RE: Revisions to project design
4725 Cheltenham Drive, Bethesda, MD

DAP - BUILDING'S BASE REDESIGN
10.18.2021

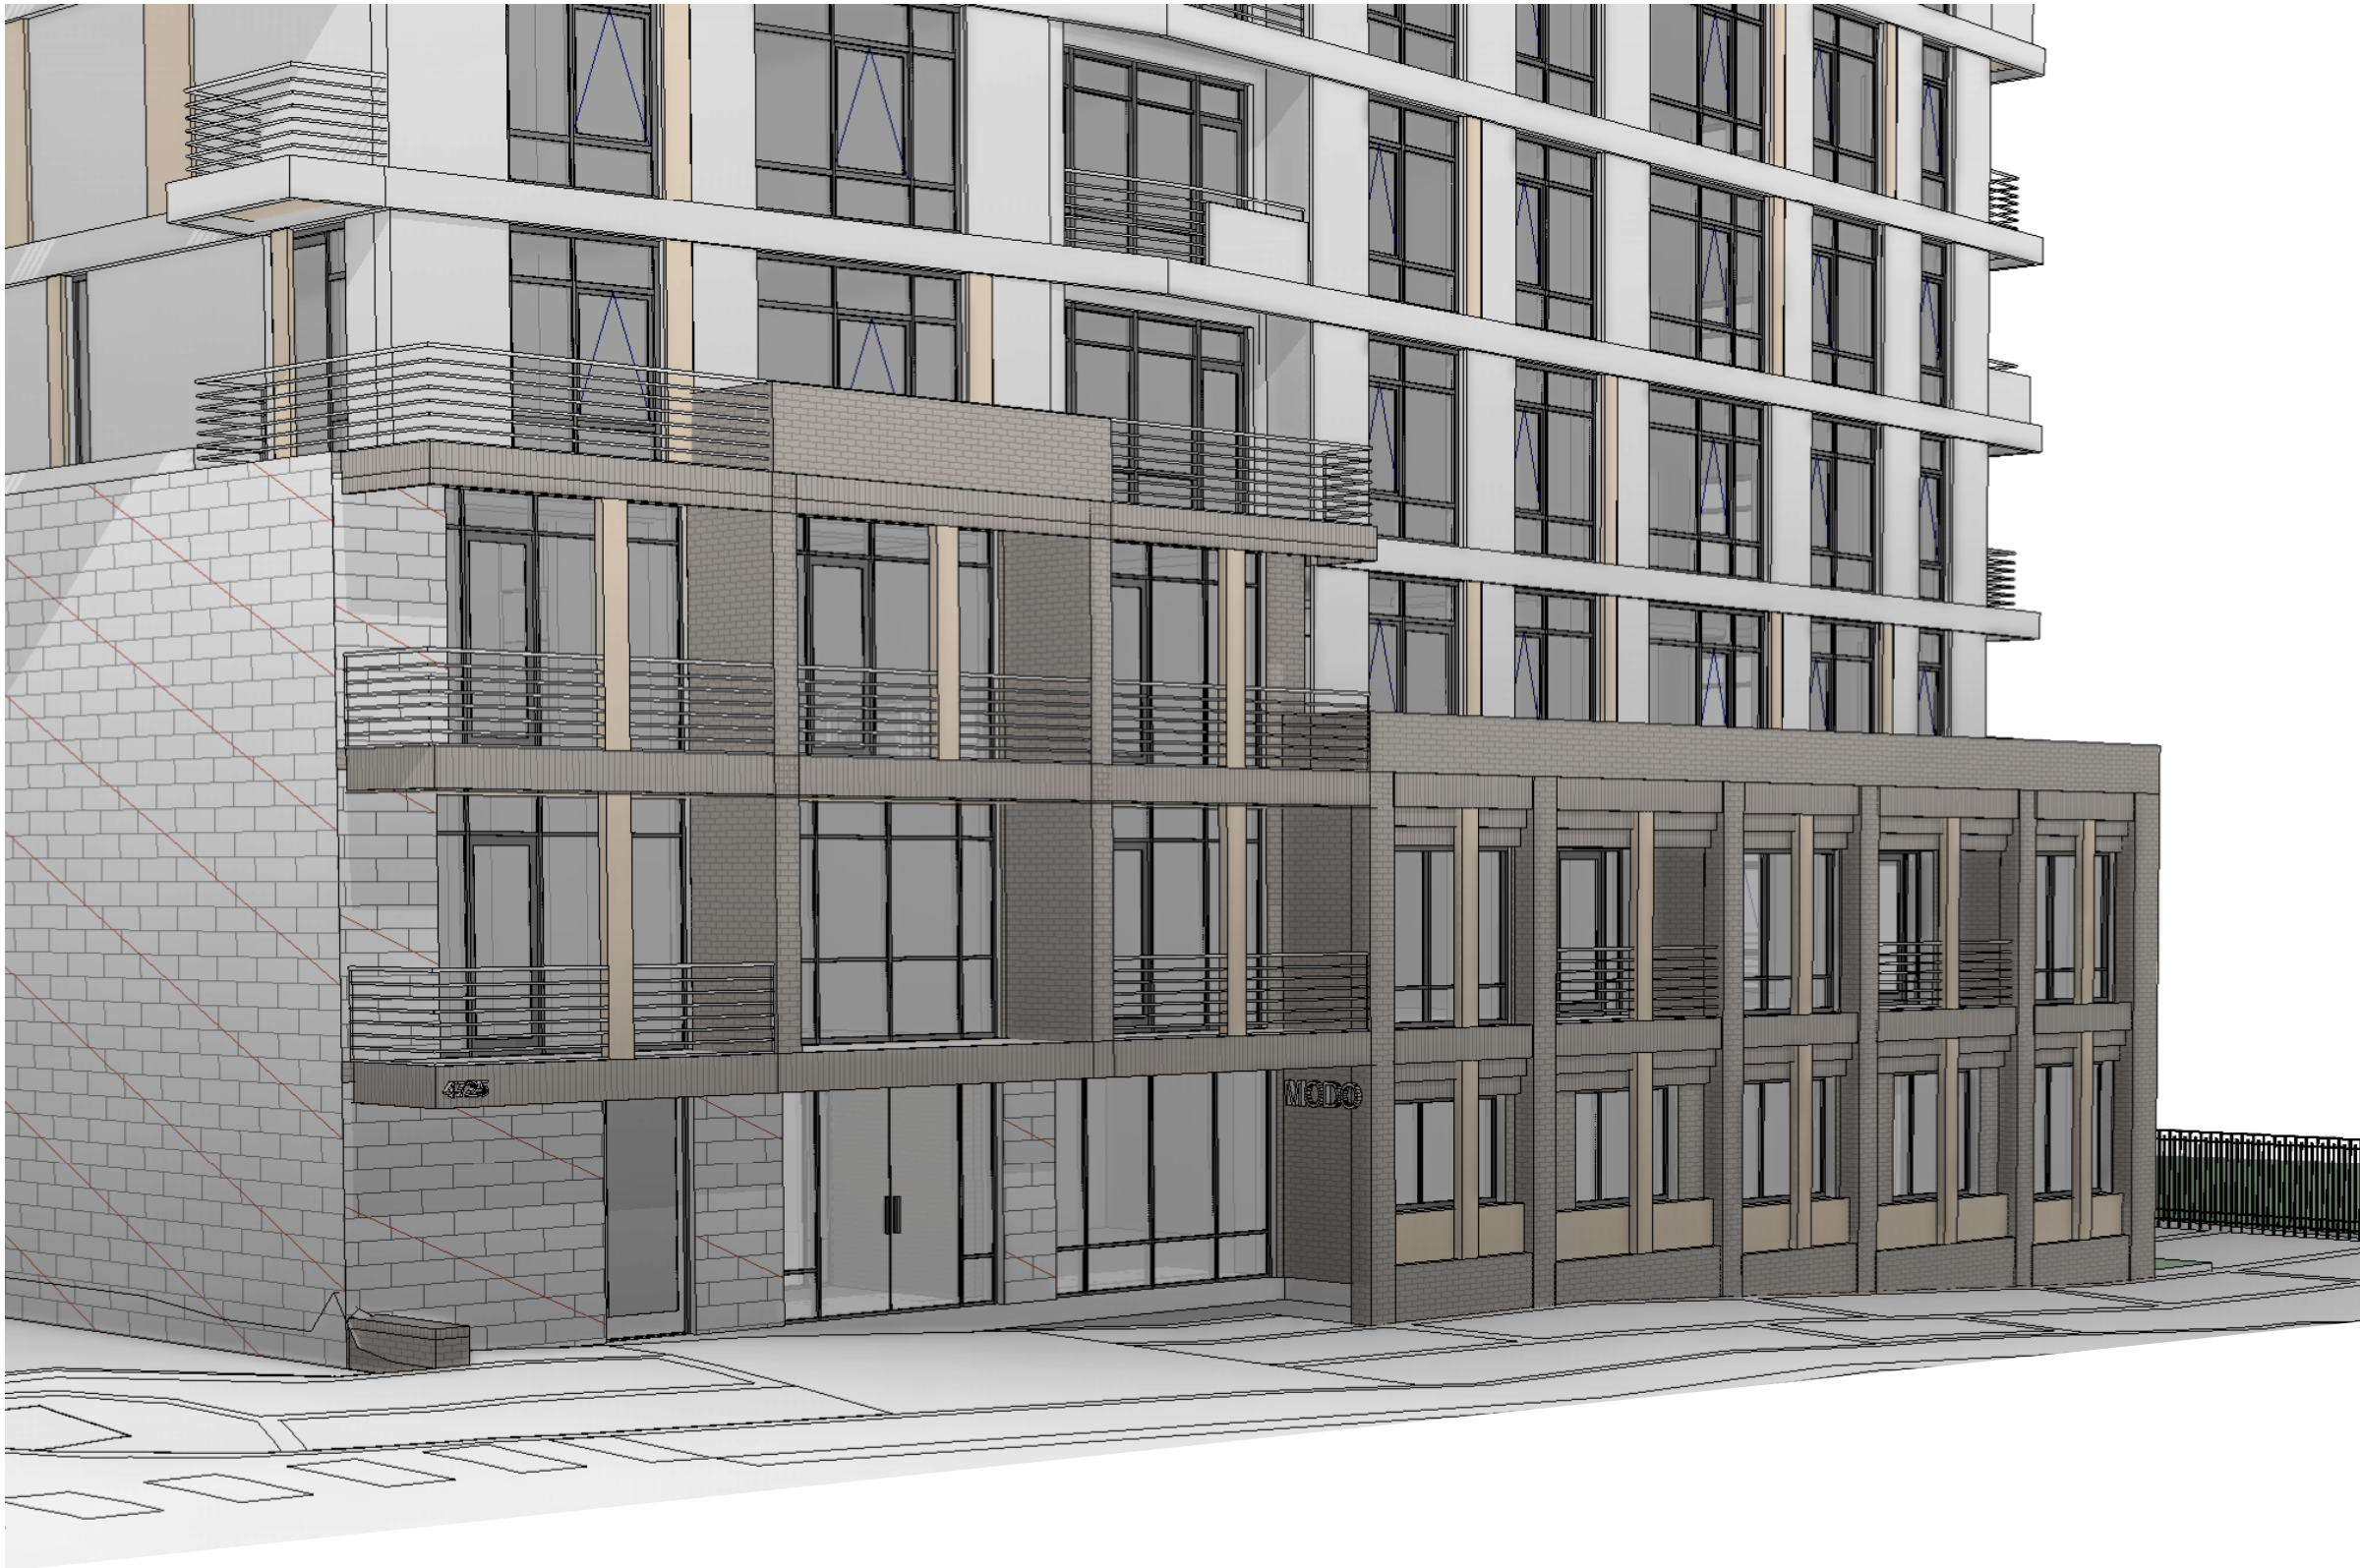
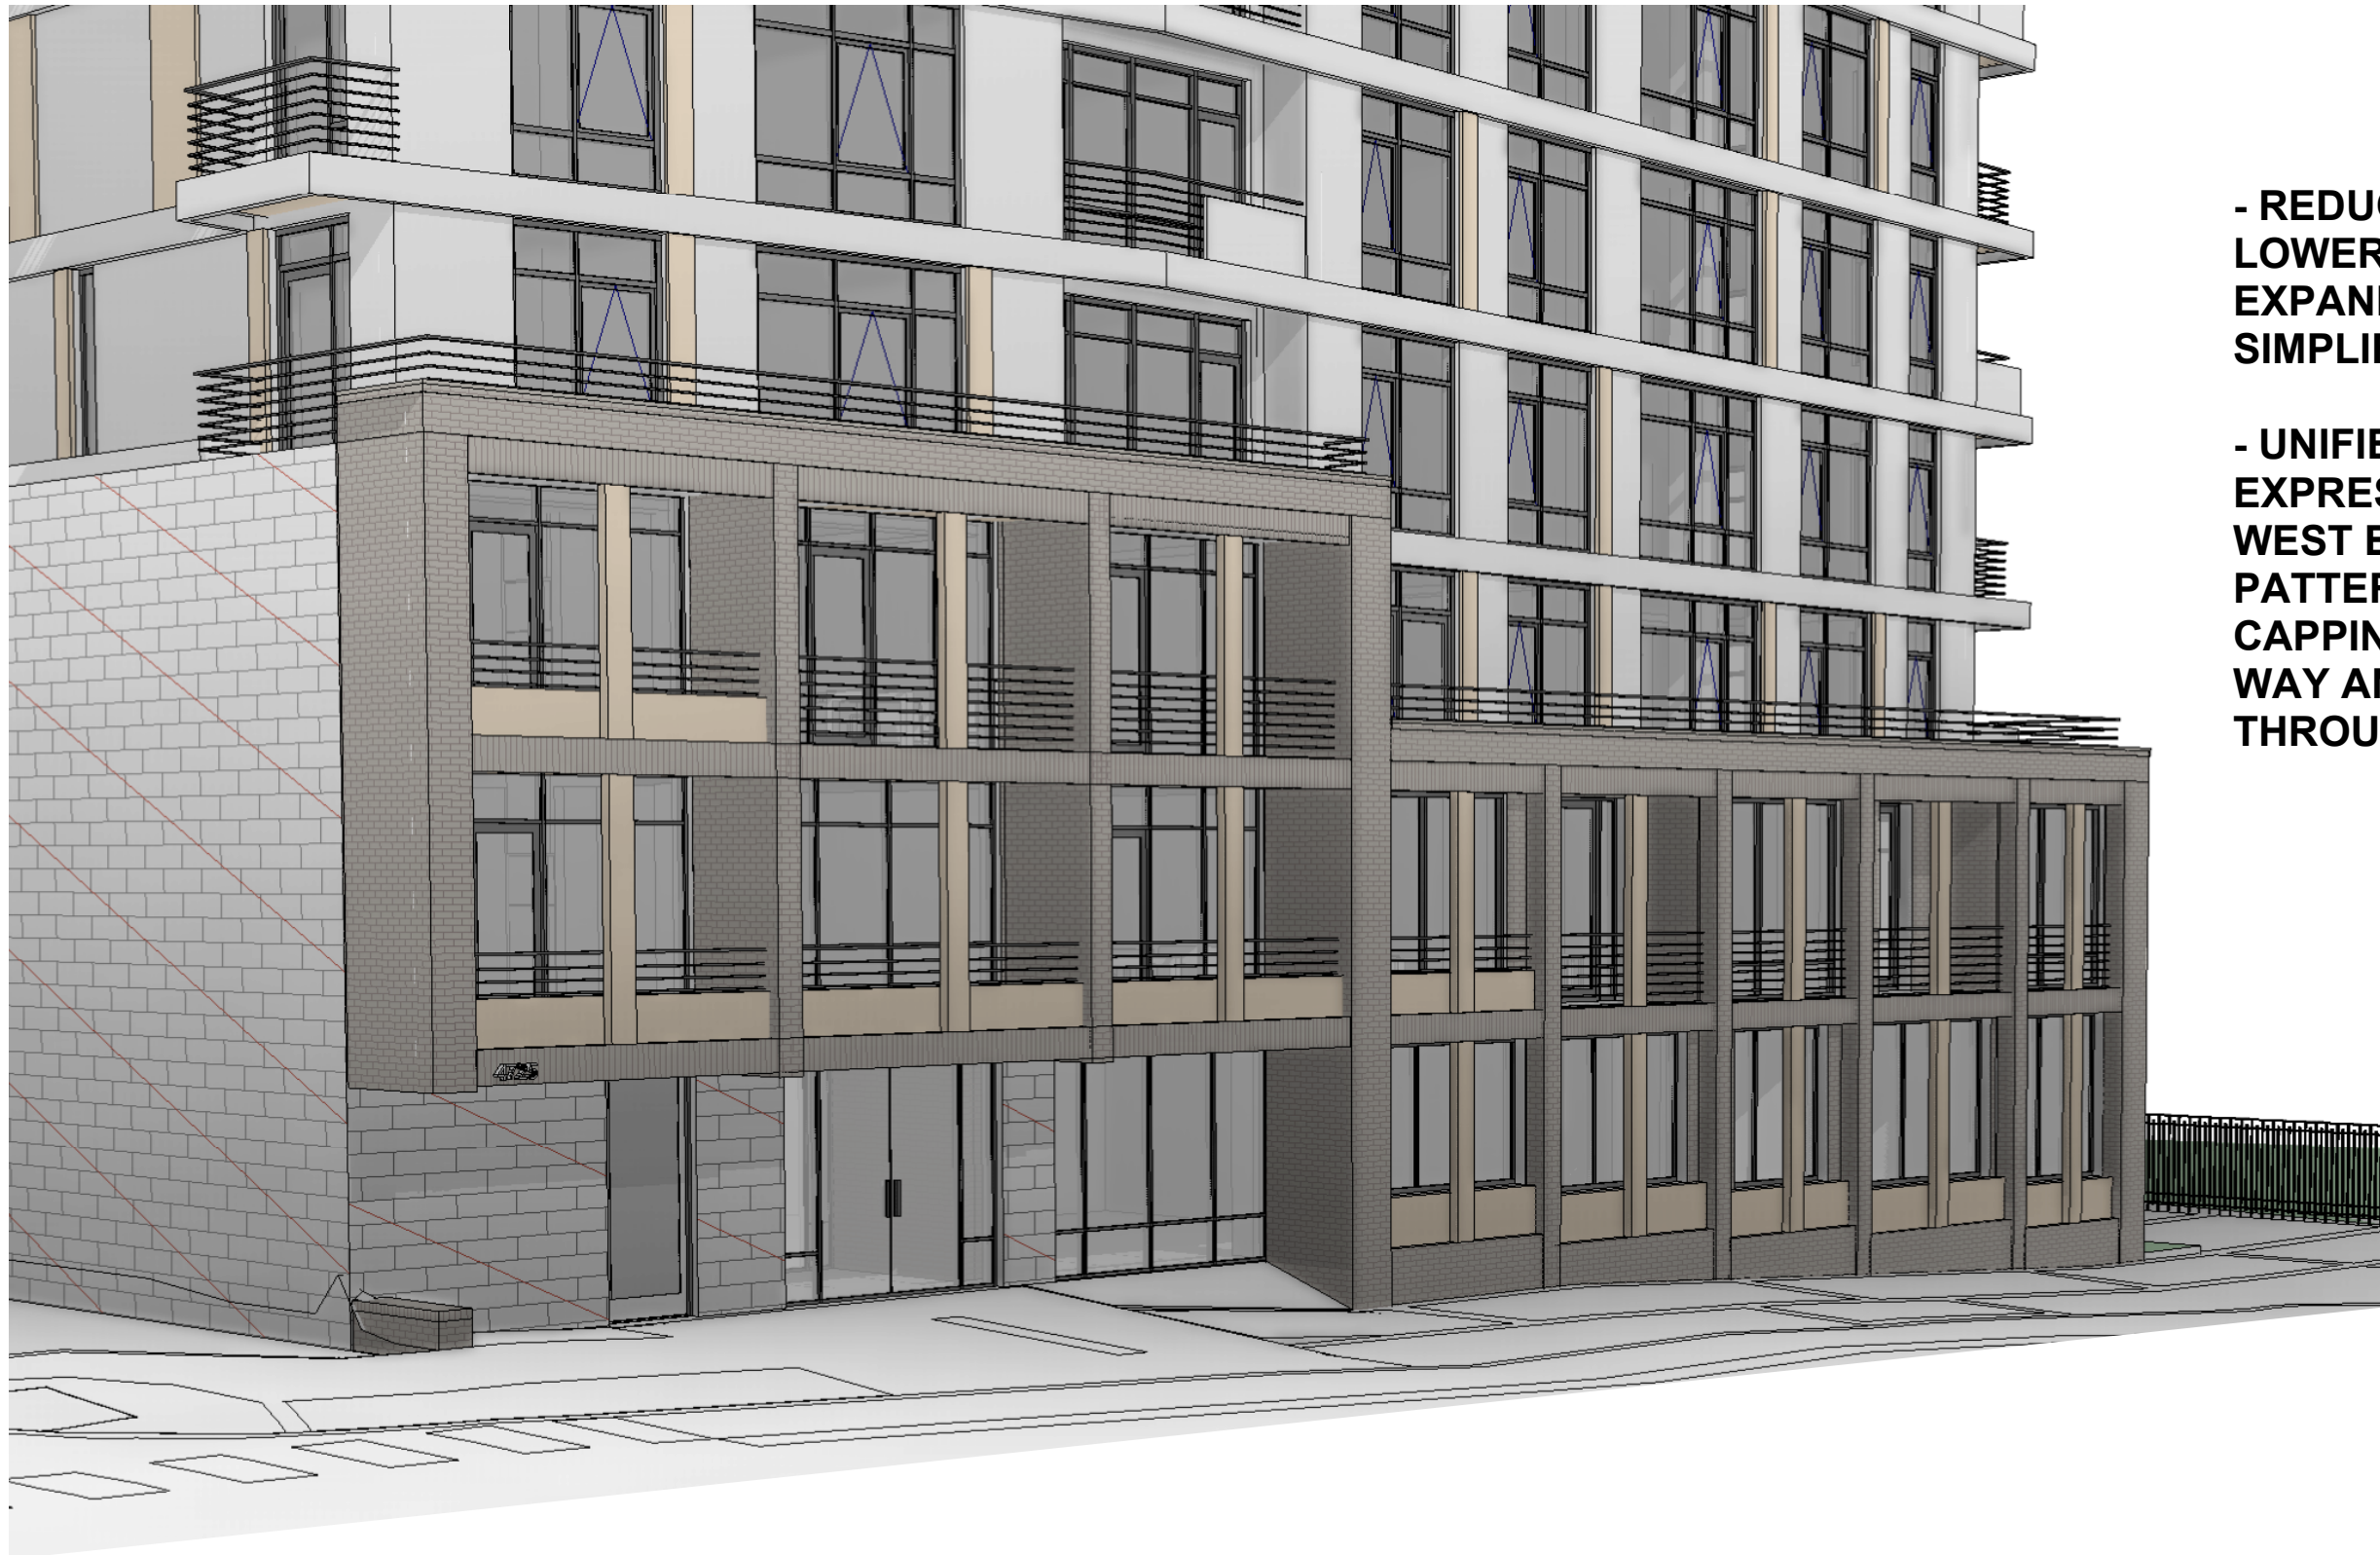
- In general, the eastern (2-story) and western (3-story) portions of the base/podium did not seem sufficiently cohesive to the DAP, who specifically pointed to the very consistent treatment in the sketch from the Sketch Plan.
- In specific, the eastern (2-story) portion seemed "earthbound" and "heavy," in unfavorable contrast to the lightness of the western (3-story) portion.
- The DAP's recommendation was to make the two portions more parallel in architectural articulation, and specifically to revise the eastern portion to be more like the western portion.

- REDUCED THE HEAVINESS BY LOWERING THE PARAPET, EXPANDING THE WINDOWS AND SIMPLIFYING THE BRICKWORK

- UNIFIED THE DESIGN EXPRESSION BETWEEN EAST & WEST BY REPEATING THE PATTERNS CONSISTENTLY, CAPPING BOTH ENDS IN THE SAME WAY AND HAVING PLANTERS THROUGHOUT

- REDUCED THE HEAVINESS BY LOWERING THE PARAPET, EXPANDING THE WINDOWS AND SIMPLIFYING THE BRICKWORK

- UNIFIED THE DESIGN EXPRESSION BETWEEN EAST & WEST BY REPEATING THE PATTERNS CONSISTENTLY, CAPPING BOTH ENDS IN THE SAME WAY AND HAVING PLANTERS THROUGHOUT
